## PLANNING REPORT

**FEBRUARY 19, 2009**

**1. OSU Medical Center Sign  
08-110AFDP/CDD**

**3900 Stoneridge Lane  
Amended Final Development Plan  
Corridor Development District**

# Proposed Signs

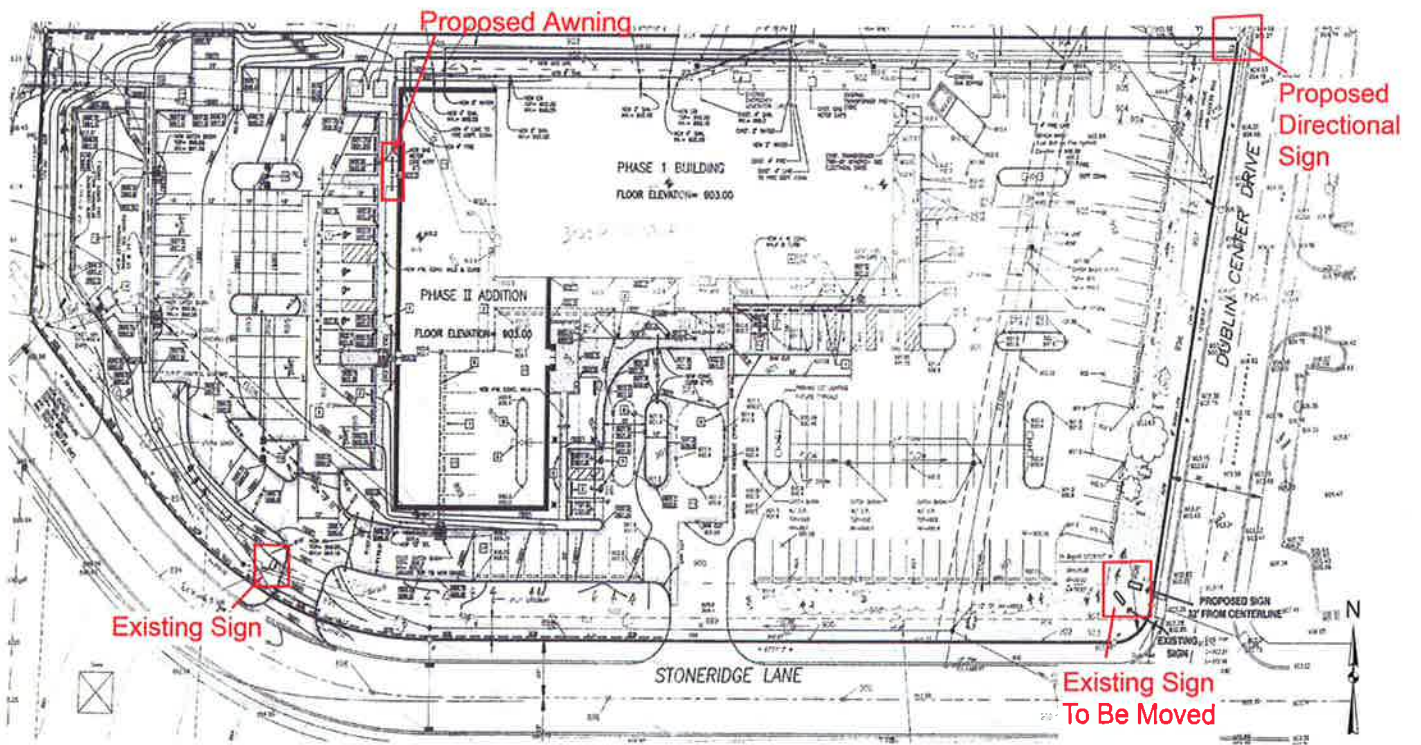
The proposed directional sign will be four square feet and 36 inches from grade. The black sign with white copy will display the building address and an arrow to direct vehicles approaching

from Dublin-Granville Road to Dublin Center Drive and Stoneridge Lane. The sign must be located eight feet from the right-of-way. It is currently shown at two feet. The plans currently show the sign located two feet from the right-of-way.

1. The proposed directional sign be placed eight feet from the right-of-way; and,
2. Any trees damaged by the relocation of the ground sign at Dublin Center Drive and Stoneridge Lane shall be replaced by the applicant.
